A G E N D A

Architectural Review Board

June 28, 2022 – 5:30 p.m.

2H

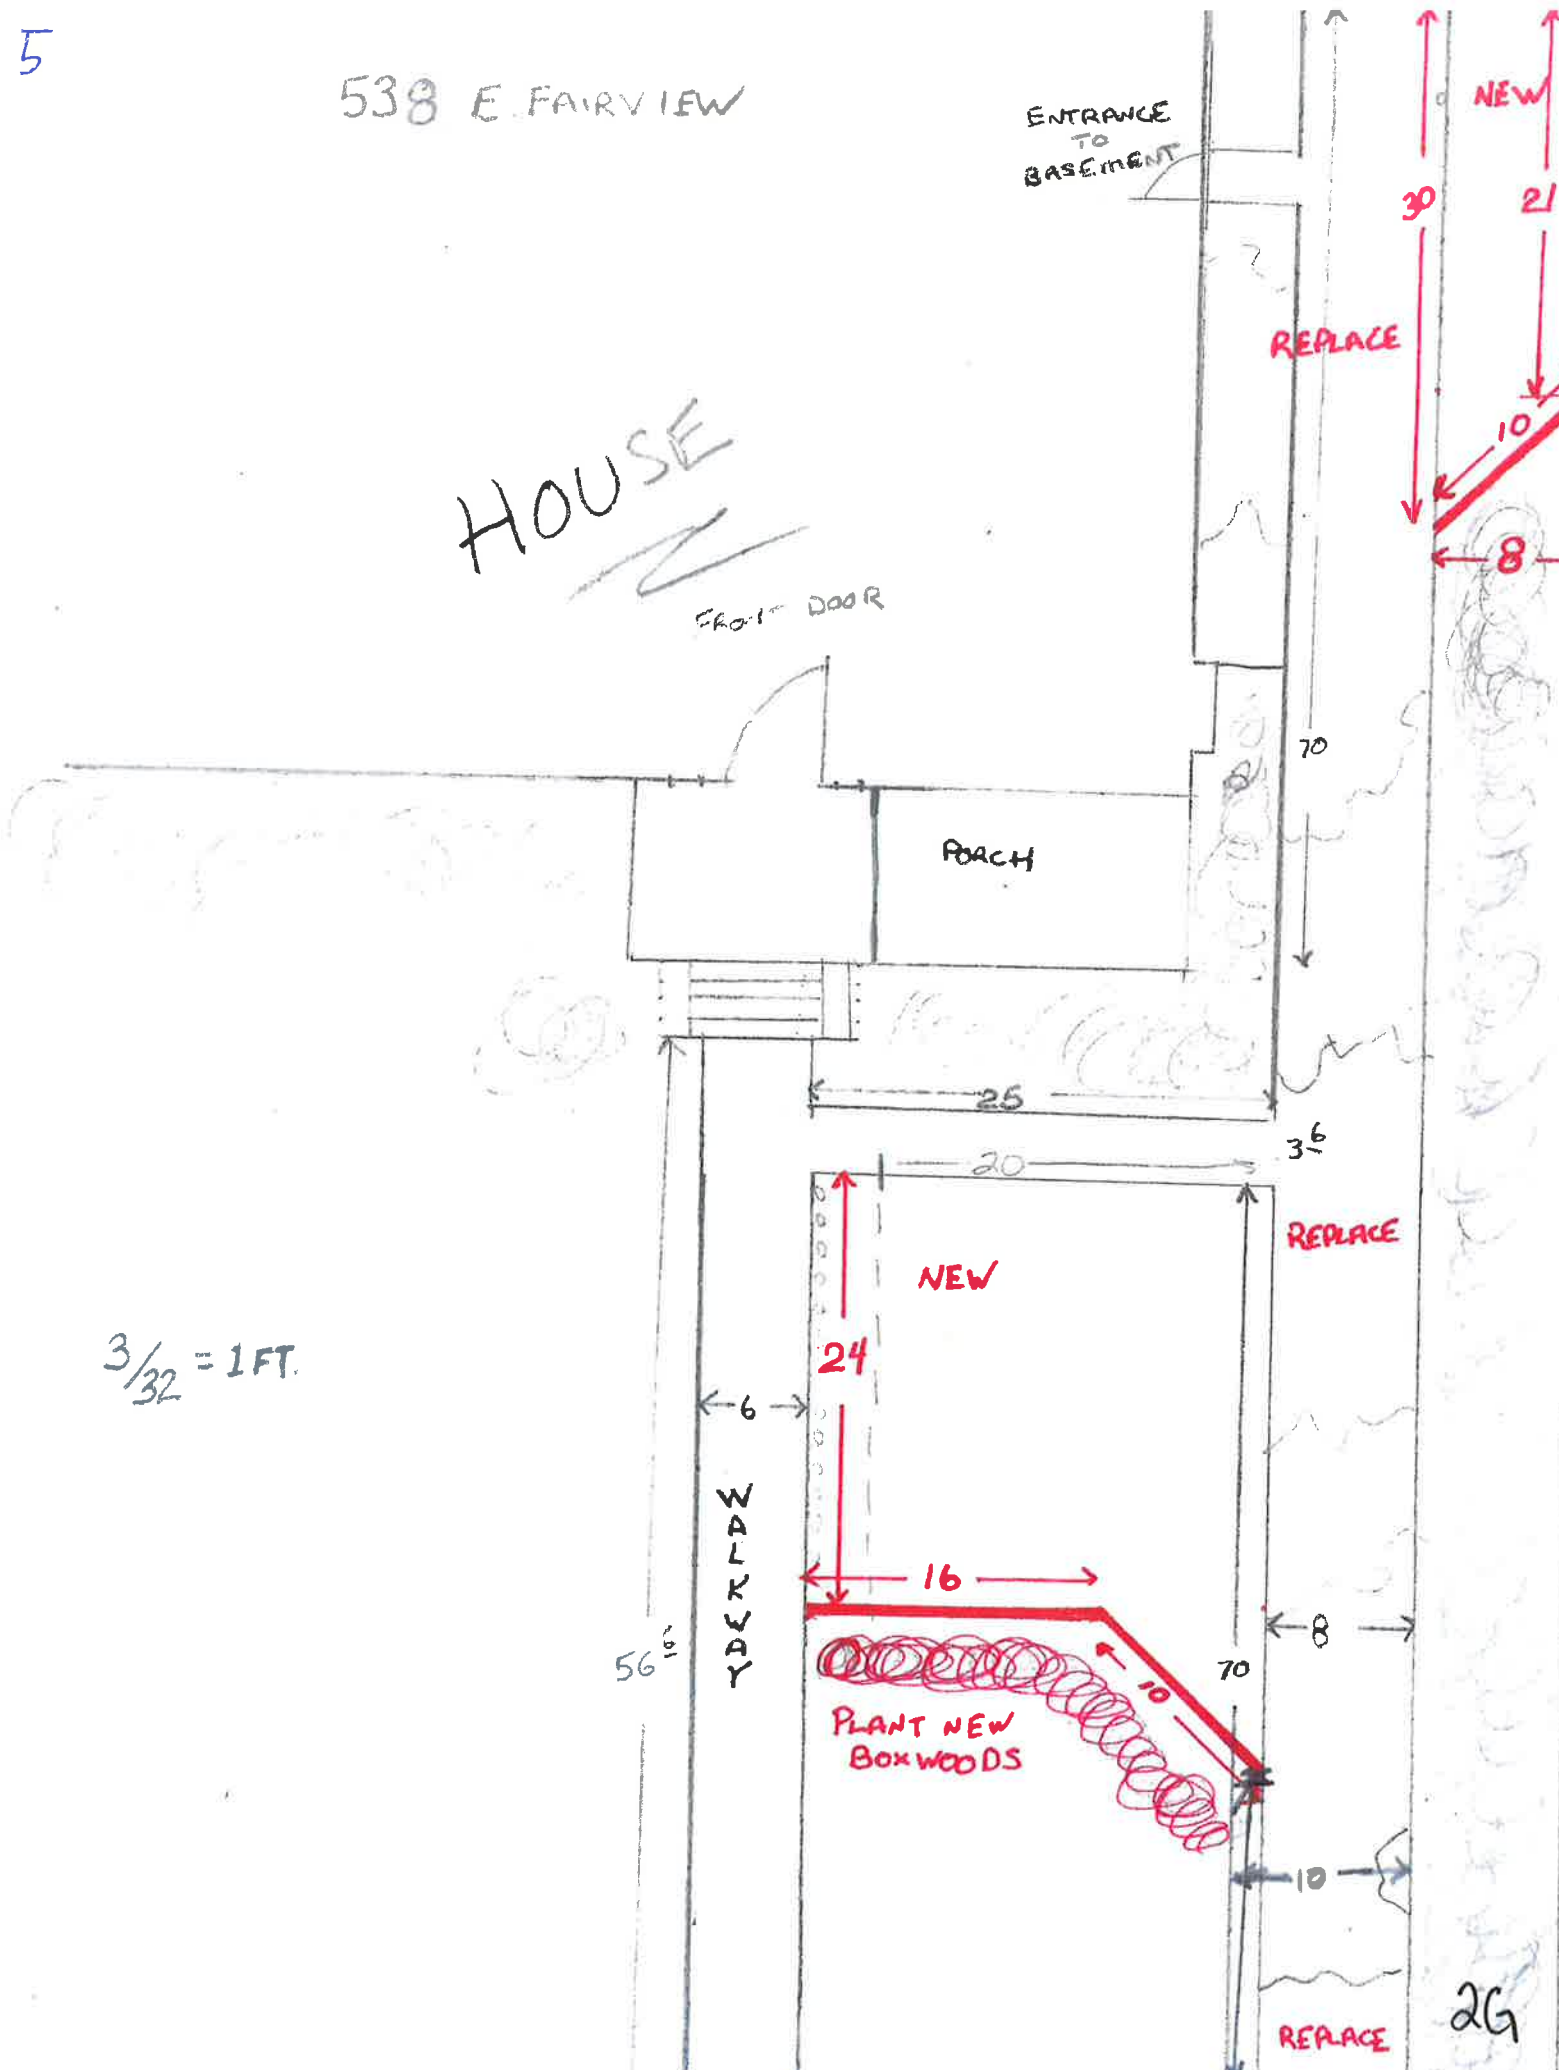
- The question that is always before the Board with violations is “would we have approved this plan if we had reviewed it **prior** to the work being done?” In the proposed configuration, it is staff opinion that answer would be no—it does not meet some of the requirements or address issues raised in reviews of similar requests (see below).

- What was discussed with Mr. Muraki was that the parking pad was too large, 24'x25' exceeds what has usually been considered, which is 20'x20'. Shortening the 25' length to 20' would have created a green, visual buffer between the pedestrian walkway to the front door and the parking area, which has been required when parking pads or driveway widenings have been approved to avoid visual and physical encroachment of vehicles on a walkway. He was advised that if the Board was to approve front yard parking, if it was deemed necessary, there would have to be more visual buffers than what is proposed.

- A boxwood hedge has been proposed. Following the lead of the landscape ordinance, the Board has required evergreen shrubs, at least 18" high at installation, spaced no

more than 36" on center. It should be specified that the gravel needs to be removed from this area and the shrubs not planted in the gravel.

- The installation of gravel at the end of the hedge near the house as discussed with staff, appears to be an effort to "clean up" that area so someone does not have to maintain lawn. Unless there is a compelling reason to do so, staff recommends that this portion of the request be denied as it appears gravel will be added for the sake of adding gravel.

- The Urban Forester has determined that it does not appear any excavation was done to install the gravel in the rear yard. It is Mr. Stringer's opinion that any attempt to remove the gravel around the live oak that is now surrounded by gravel would be more detrimental than leaving it in place.

- The current boxwood hedge is in the city Right of Way. There is a proposed sidewalk project on Fairview Avenue which would likely remove that hedge and the additional visual buffer it provides.

- Typically pools have been filled with dirt and sodded over in previous removals. This pool was approved for installation by the ARB in 2009.
- If the parking pad is approved as amended or discussed, it is the recommendation of staff that the front lawn be re-sodded (removing excess gravel and pine straw); and that the rear gravel be left in place as installed to insure the long term health of the live oak tree.

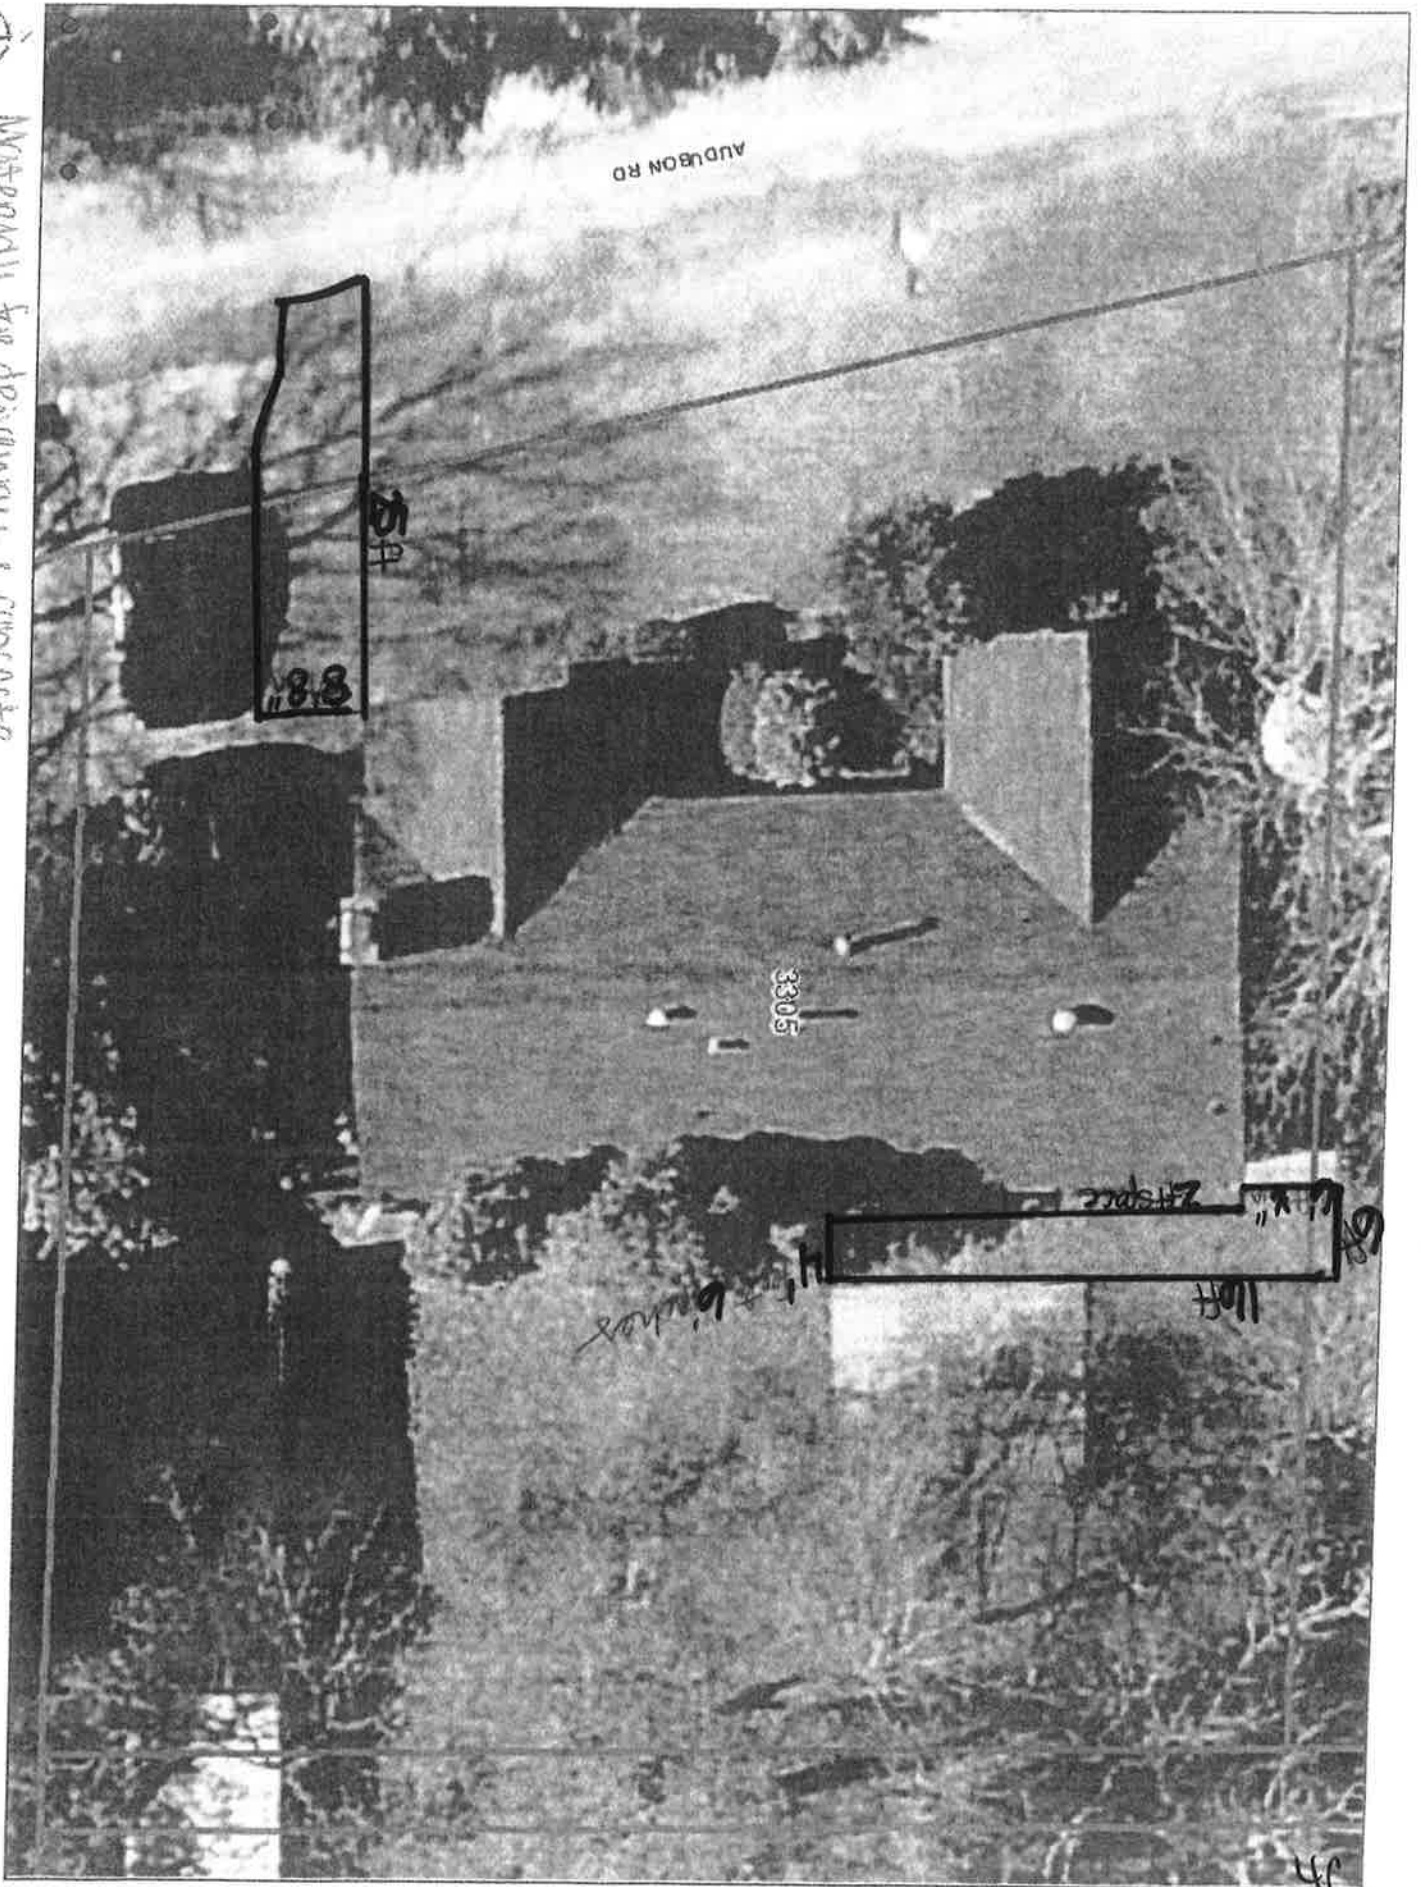
- The driveway expansion does not encroach on the footprint of the house, no objection.
- No objection to tying decks together.

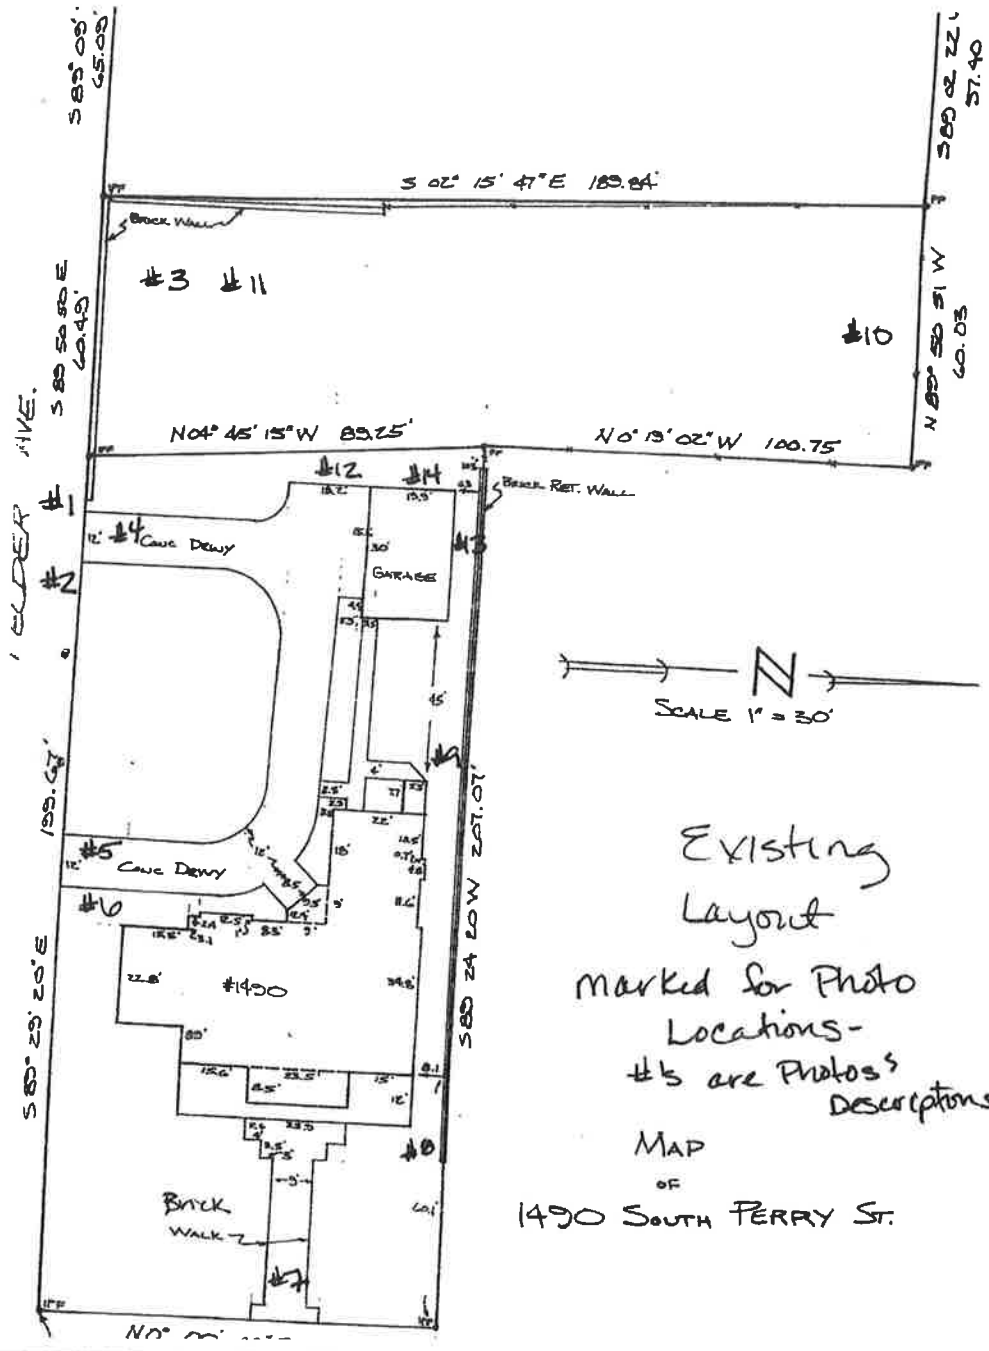
- Generally the Board has approved fences 36”-48” high in the front yard—anything in front of the front corner of the house. The Board needs to determine if they would approve a 60” fence on the Felder side of the property, installed behind the existing hedges. The Board approved a front yard fence (not a corner lot) on Fairview several years ago where the owner had the option of constructing a 4’ fence in front of an existing hedge, or a 6’ fence behind it.
- Urban Forestry recommends replacement of the tree with a canopy tree, 2.5” caliper in consultation with the Urban Forester.
